SONI and NIE Networks' proposal for the general application of technical requirements in accordance with Articles 13 – 28 of the Commission Regulation (EU) 2016/631 establishing a network code on requirements for grid connection of generators

16 May 2018

Figure 1 Maximum Power Capability Reduction with Falling Frequency

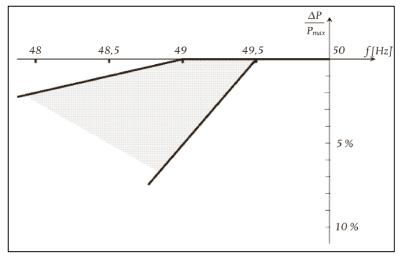
One respondent commented that a gas turbine technology output at falling frequency is non-linear nor can it be controlled since intrinsic to the generating unit itself. The 49 Hz, 2% power drop at the specified ambient conditions is not a realistic characteristic for any gas turbine, regardless of whether the technology is single or multi shaft. They commented that EUTurbines have been presenting examples and explanations including the characteristics, of GT technology since 2012. The proposals presented here exceed the presentations from EUTurbines. They also comment that every gas turbine has its own characteristics. They suggest that a possible approach is to leave the characteristic as defined in the proposals and to request GT manufacturer to provide expected power deviation function of ambient temperature.

One respondent commented that Article 13.5 is used to complement Article 13.4, by providing ambient condition and thus taking into consideration technical capabilities of the correspondent technology. They suggest a possible approach is to leave the characteristic as defined as reference for all and to request GT manufacturer to provide expected power deviation function of ambient temperature. They request that the TSO note that these requirements are critical only at full power for GT characteristic and the design is intrinsic to the all Gas Turbine category. They further note that the requirement cannot be tested and thus it is difficult to define improvement and it does not drive competition.

One respondent commented that compensative systems are risky and not fully beneficial. They can lead to flame out and are slow acting logic, not in line with supporting the initial stages of RoCoF. They reference the EUTurbine response to the ENTSO-E IGD on frequency parameters.

The reduction rate of 2% of the maximum capacity at 50 Hz per 1 Hz frequency drop is in alignment with the ENTSO-E IGD. On page 7 section 2 it states it would make sense to have different requirements for different synchronous areas, for example the UK, IE = 2%/Hz. At frequencies above 49.5Hz a drop in active power output is not permitted. This is a change as compared to the consultation proposal of 49Hz. Having considered the

consultee's comments regarding capability under steady state conditions The TSO believes no power reduction above 49.5Hz to be reasonable for SPGM Gas Turbines and in alignment with the ENTSO-E IGD's recommendation regarding steady state response. However The TSO would expect SPGM Gas Turbines performance to be better than this in the transient time frame (see table on page 7 of ENTSO-E IGD up to 30secs)

The reduction rate of 2% of the maximum capacity at 50 Hz per 1 Hz frequency drop is in alignment with the ENTSO-E IGD. On page 7 section 2 it states it would make sense to have different requirements for different synchronous areas for example UK, IE = 2%/Hz. At frequencies above 49.5Hz a drop in active power output is not permitted. This is a change as compared to the consultation proposal of 49Hz. Having considered consultees comments regarding capability under steady state conditions The TSO believes no power reduction above 49.5Hz to be reasonable for SPGM Gas Turbines and in alignment with the ENTSO-E IGD's recommendation regarding steady state response. However The TSO would expect CCGT performance to be better than this in the transient time frame (see table on page 7 of ENTSO-E IGD up to 30secs)

As per the ENTSO-E IGD the PGM should provide the characteristics expected over a full temperature range (eg-10°C - 40°C). The performance specified under Article 13.5 is at 10°C

Figure 5: FRT capability PPM connected at voltage less than 110 kV

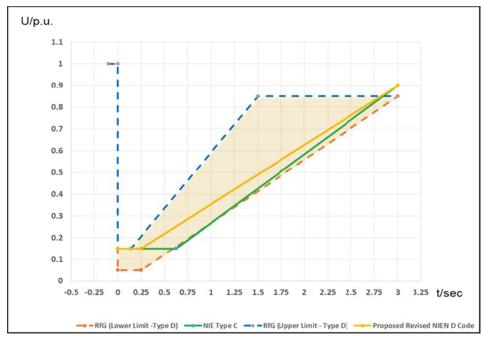
250ms is deemed too long and outside international practice, we suggest 150ms

The current Grid and Distribution Code requirements require PPMs to remain connected for much longer fault durations than 150 ms or even 250 ms. As set out in section 3.1 the intention is to maintain the existing requirements in the Grid Code were possible. We have chosen 250 ms to as closely align with the existing requirements as possible.
